Model No.
000764-20

Product Specifications:
B-0290 Removable Seat

Old Style Seat

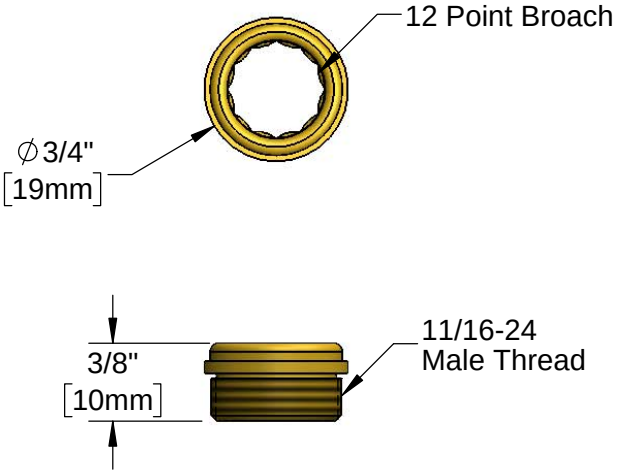
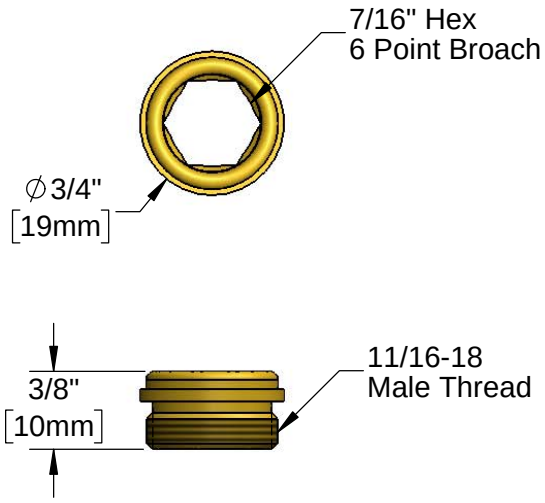
Note: (2) Different B-0290 Seats, as of March1997

Old Seats	New Seats
Broach	12 point	6 point
Threads	24 per Inch	18 per Inch

Old Seats Only Fit Old Faucets. New Seats Only Fit New Ones. Since We Weren't Sure Which Body You Would Be Repairing Today, We Have Included Both Types.
